PLANNING & ZONING COMMISSION

Monday, July 22, 2024 at 6:30 PM

**PRELIMINARY PLAT**  
**LOT 1, BLOCK 1**  
**GREENWAY TRAILS**  
 ALSO BEING A REPLAT OF LOT 1, PRIDDY ADDITION, AN ADDITION TO THE CITY OF CORINTH ACCORDING TO THE PLAT RECORDED IN CAB. N, SL. 382, PLAT RECORDS, DENTON COUNTY, TEXAS  
 M.E.P. & P. R.R. CO. SURVEY, ABSTRACT No. 911  
 CITY OF CORINTH, DENTON COUNTY, TEXAS  
 GROSS AREA: 14.1681 ACRES  
 ZONED: PLANNED DEVELOPMENT DISTRICT #63 (GREENWAY TRAILS)

<b>Meeting Date:</b>	7/22/2024	<b>Title:</b>	Enclave at Canyon Ranch Planned Development (PD) Rezoning Request (Case No. ZAPD24-0003)
<b>Strategic Goals:</b>	<input type="checkbox"/> Resident Engagement <input type="checkbox"/> Proactive Government <input type="checkbox"/> Organizational Development <input type="checkbox"/> Health & Safety <input type="checkbox"/> Regional Cooperation <input checked="" type="checkbox"/> Attracting Quality Development

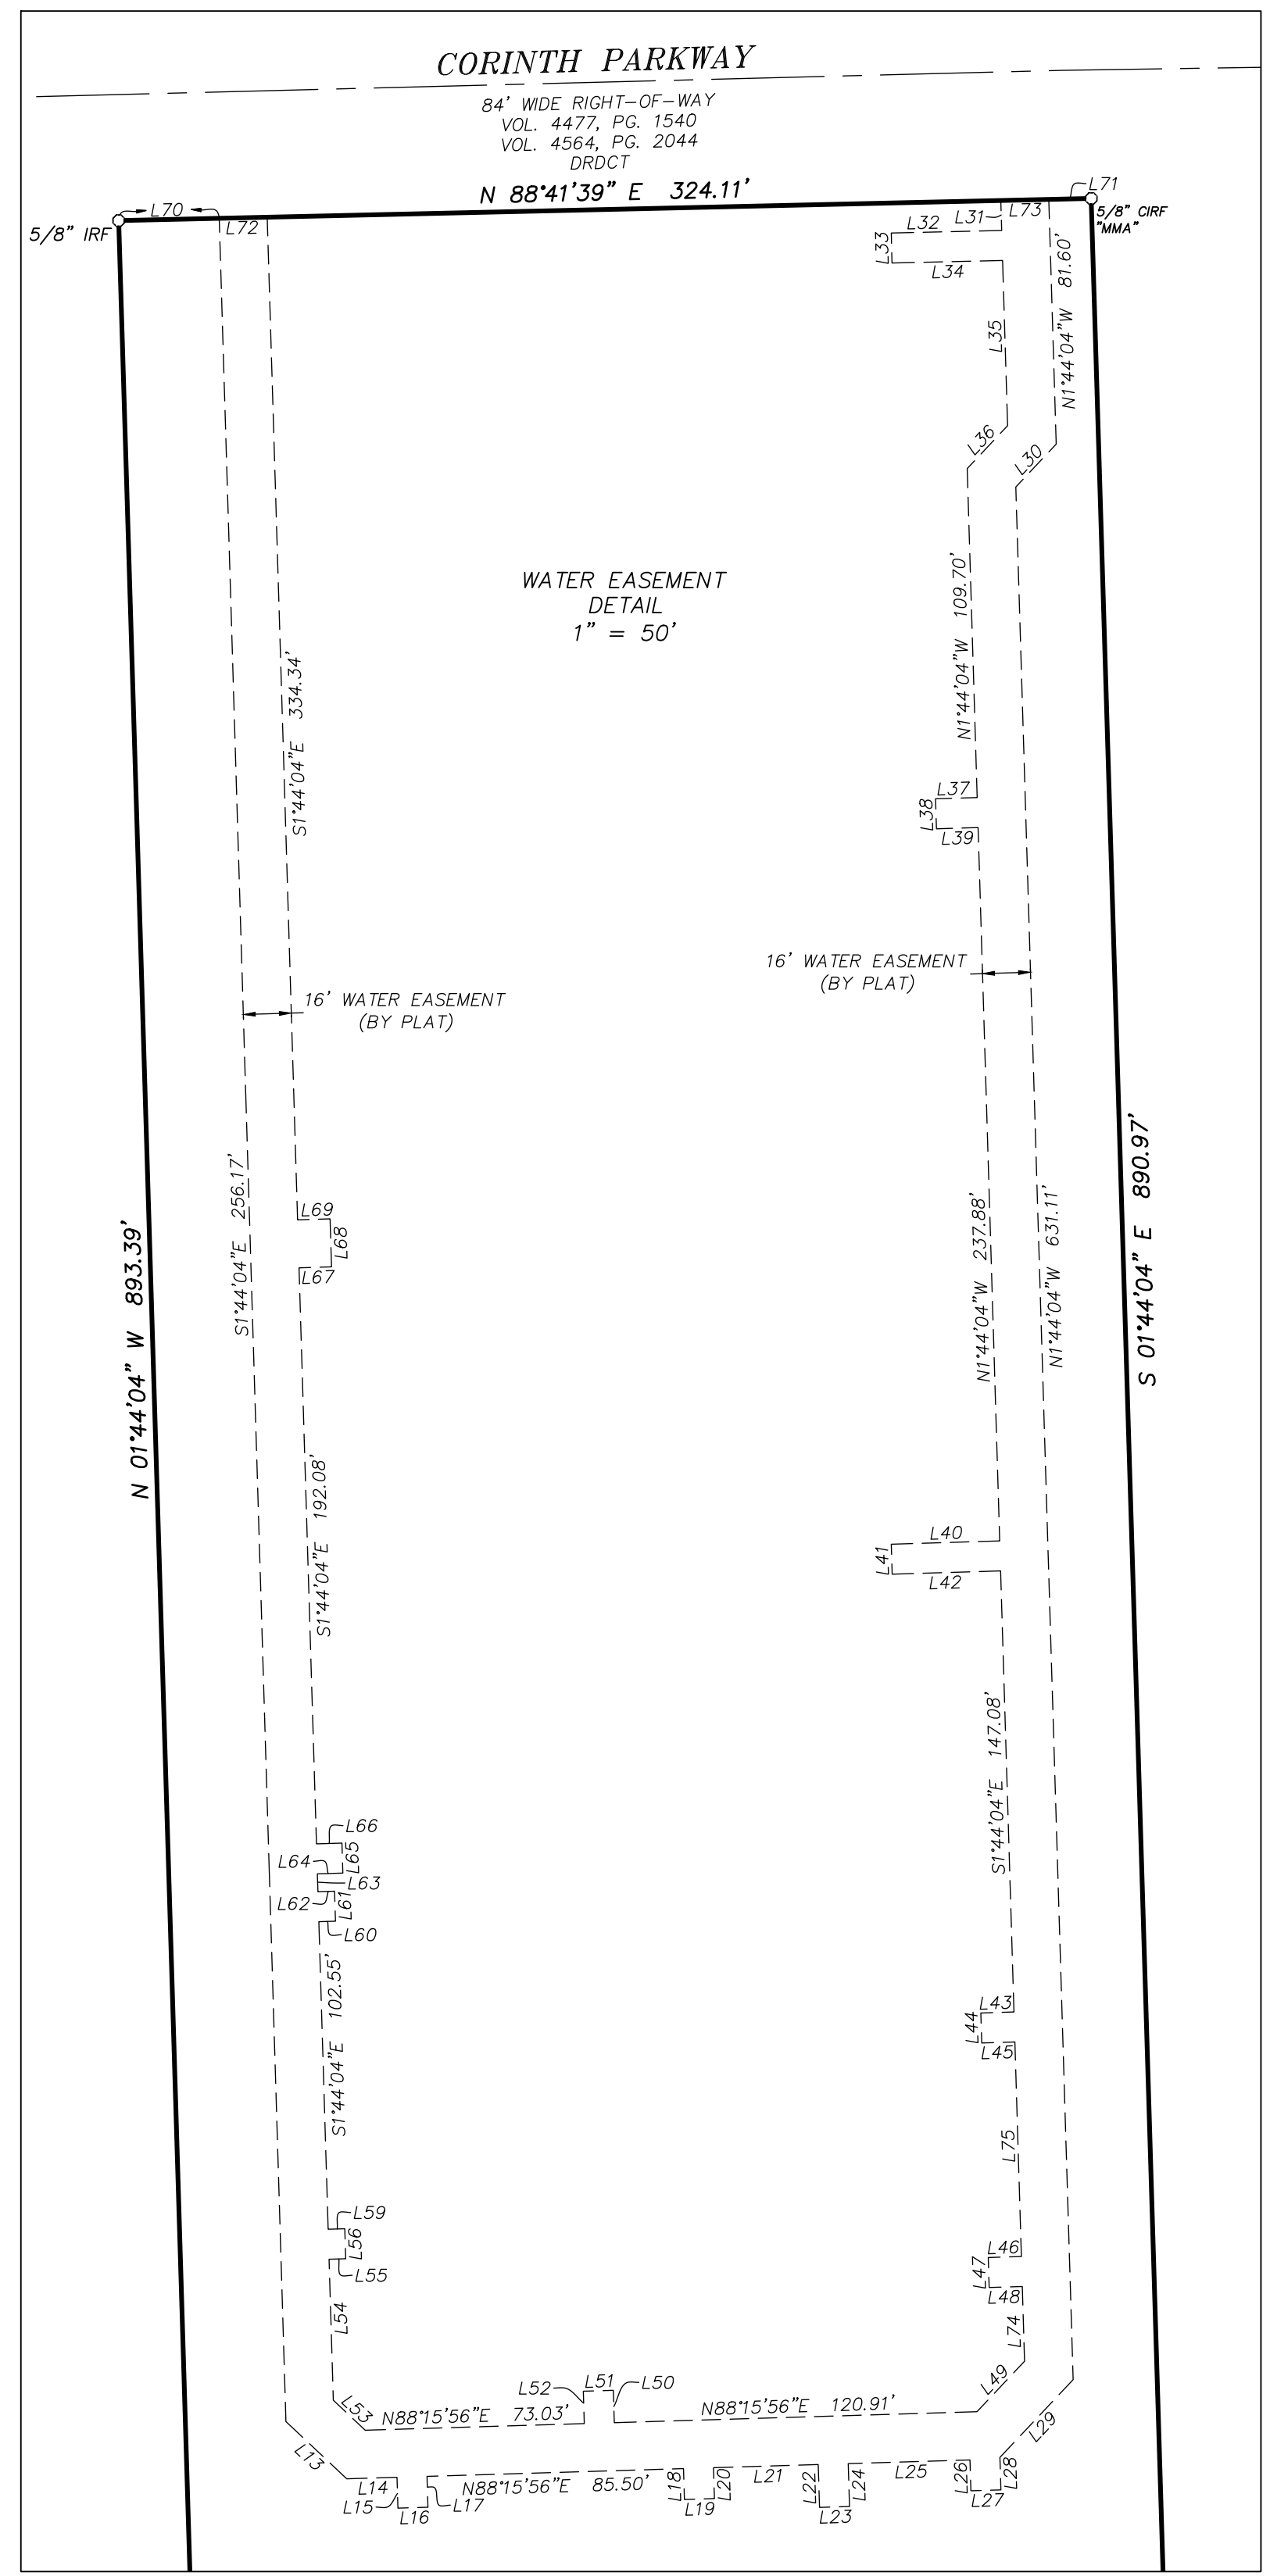
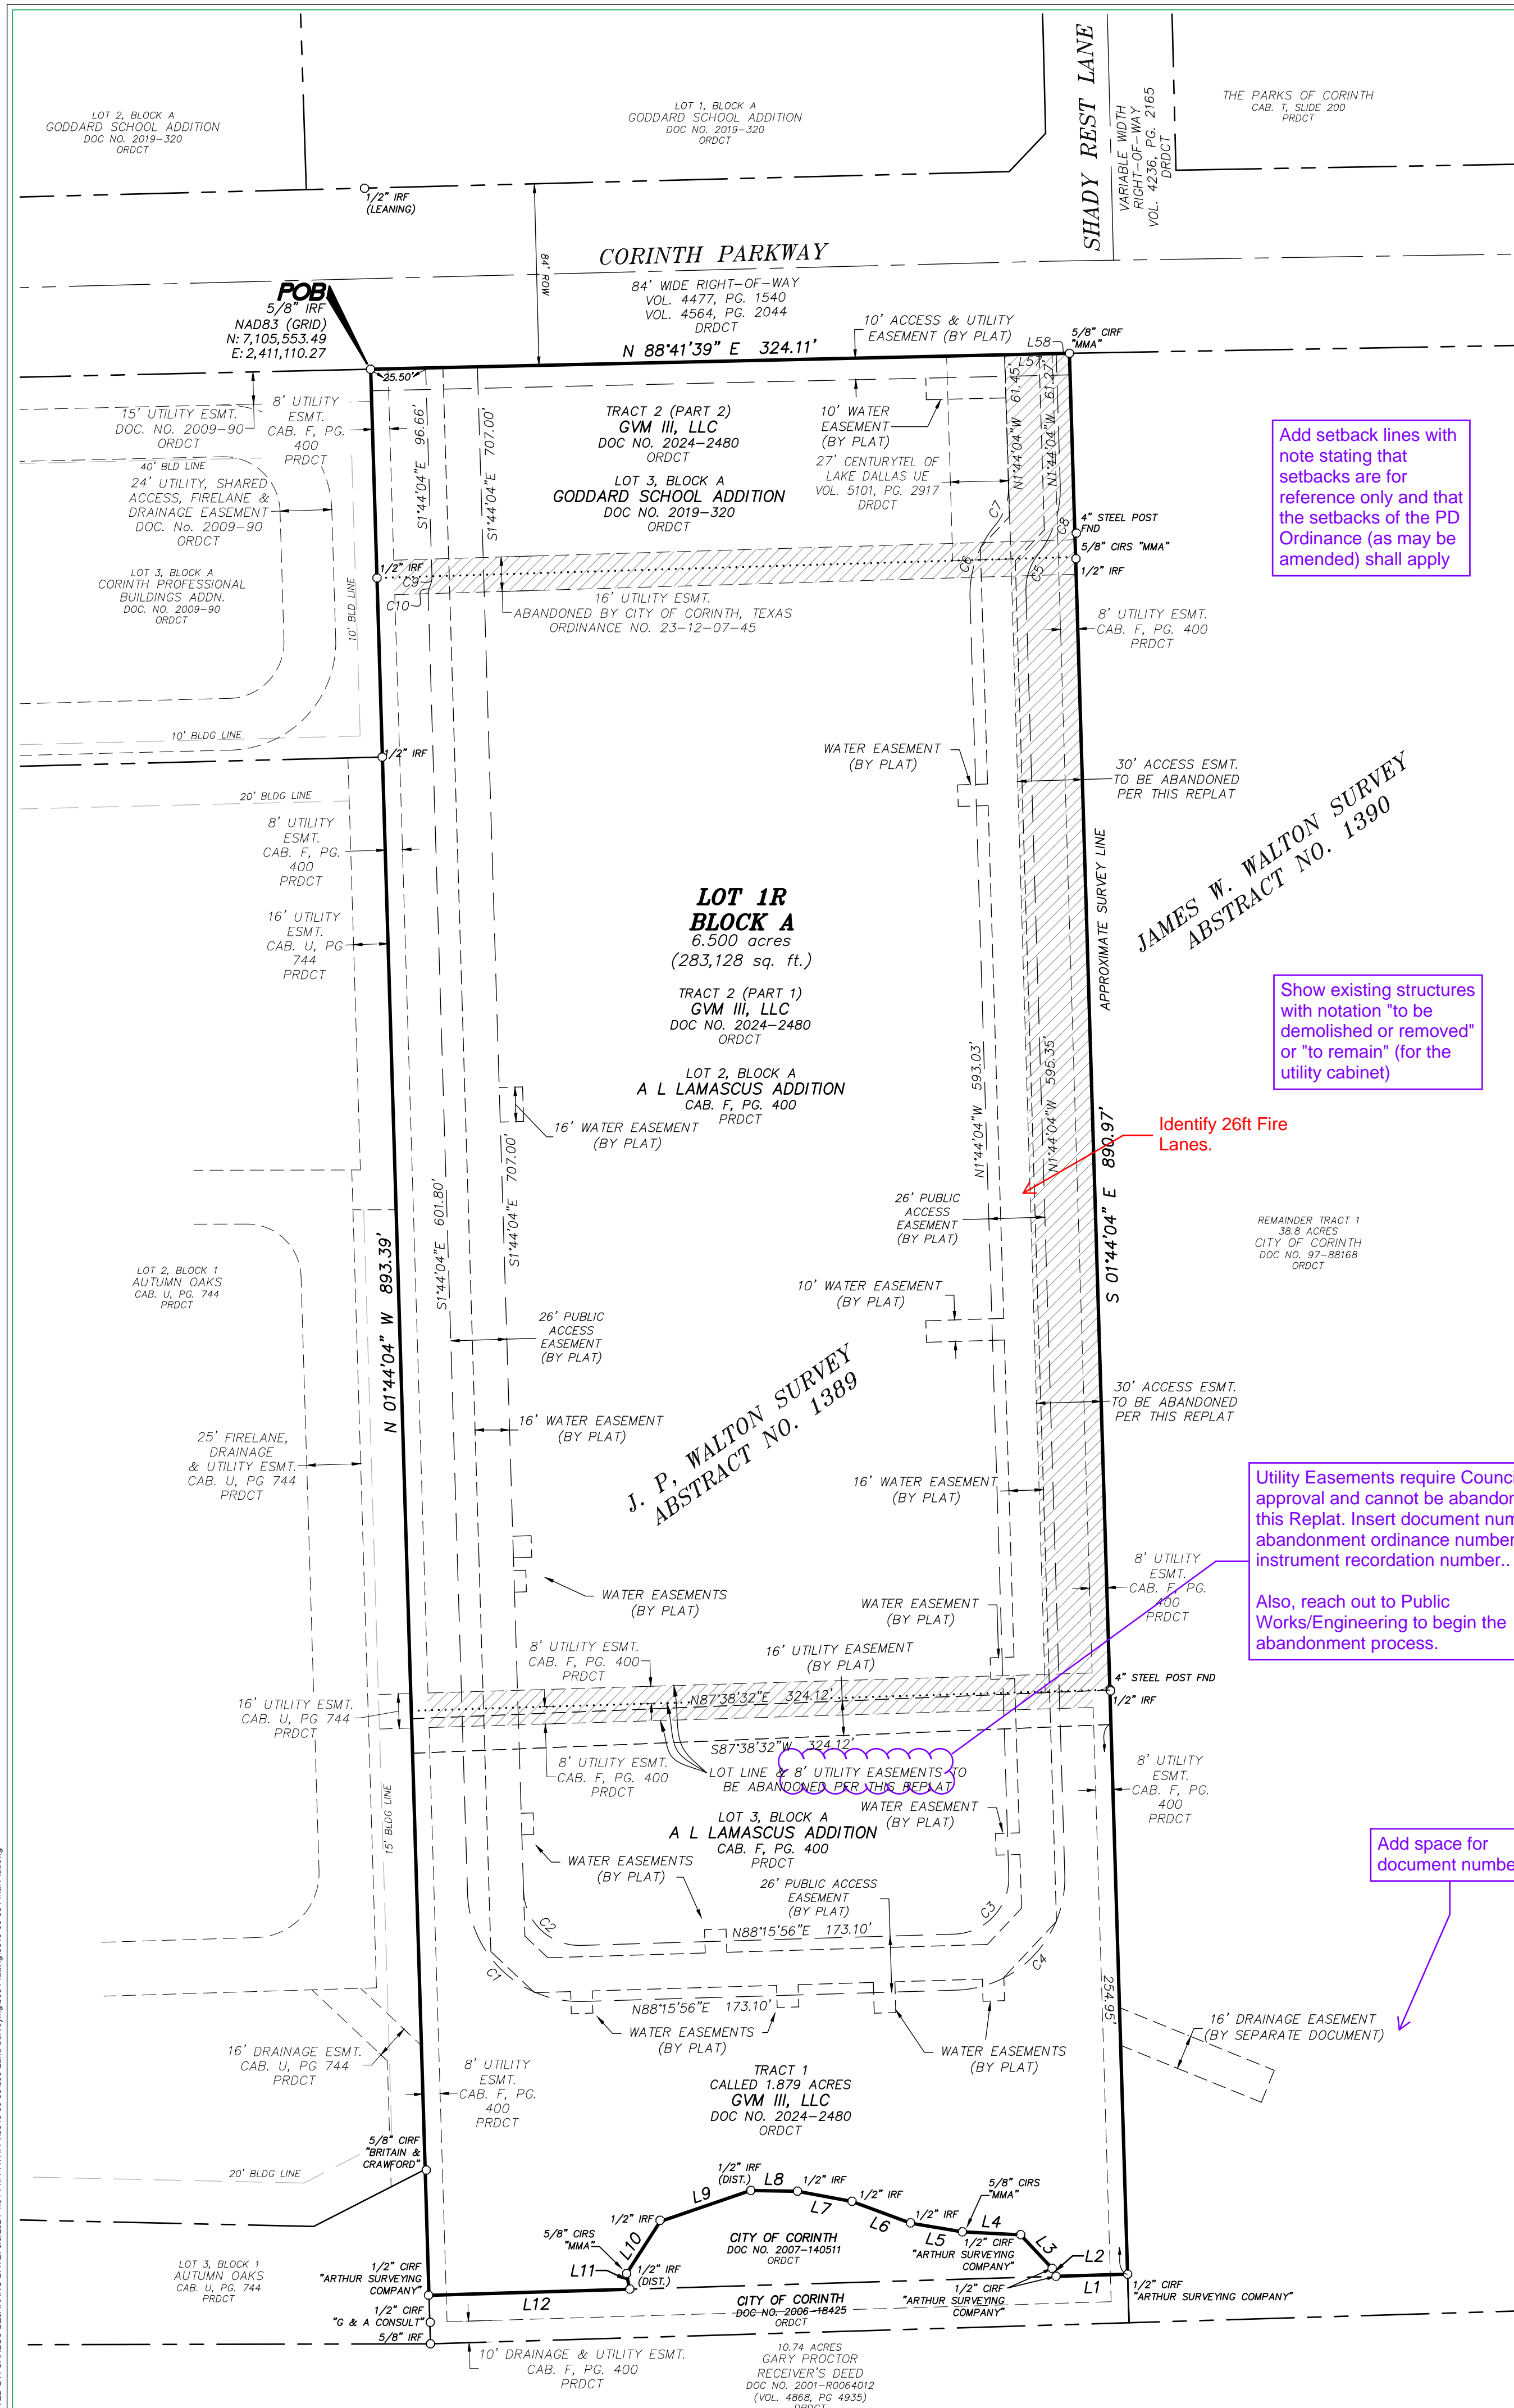
For reference, any public improvements will require a development agreement and financial security as stipulated in UDC.

Add setback lines with note stating that setbacks are for reference only and that the setbacks of the PD Ordinance (as may be amended) shall apply

Show existing structures with notation "to be demolished or removed" or "to remain" (for the utility cabinet)

Add space for document number

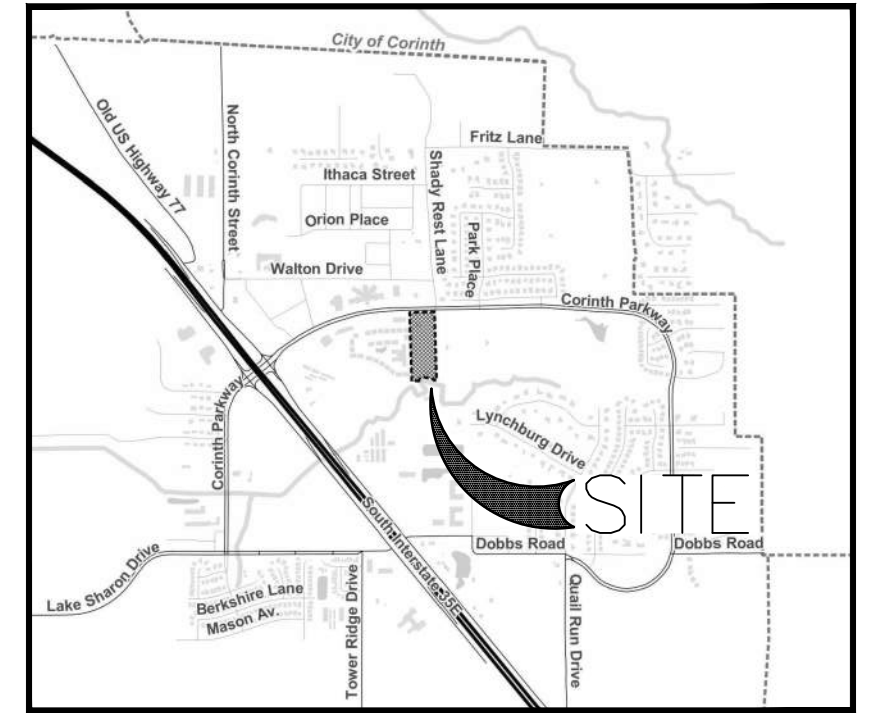
Add the following:  
 - Fire Lane Easement language UDC 3.03.04 M.2  
 - Lienholder's Ratification of Plat Dedication (if applicable) UDC 3.03.04 M.4

1 VARIABLE HEIGHT MAIN ENTRY SIGN MONUMENT ELEVATION

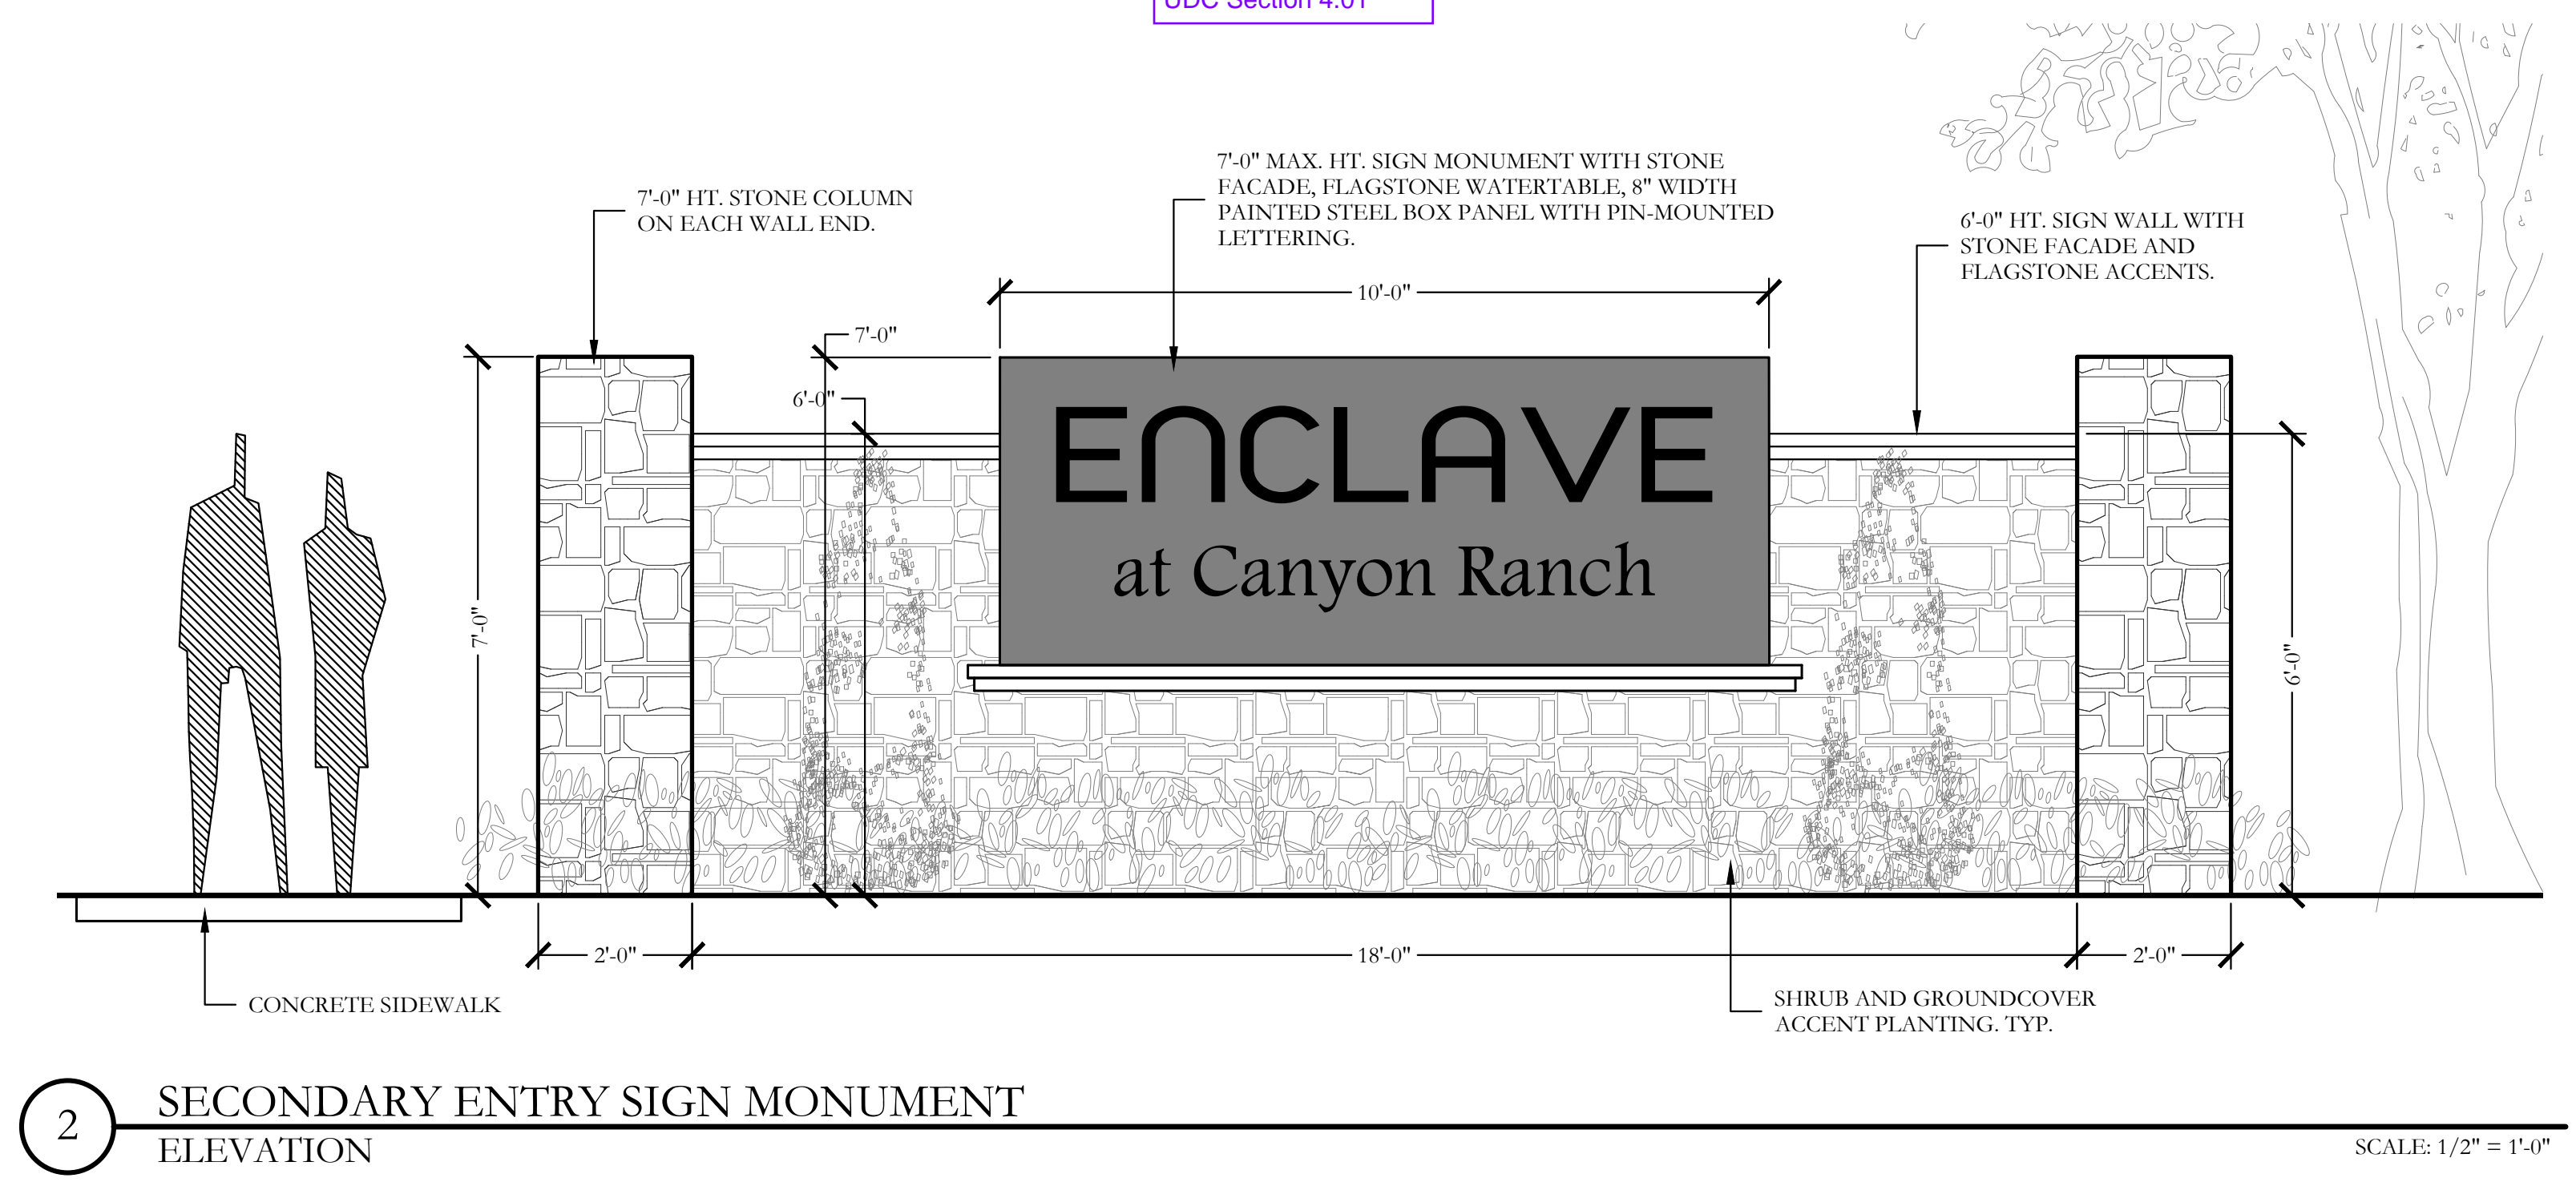
Add note: Signage for reference only. All signage to comply with UDC Section 4.01
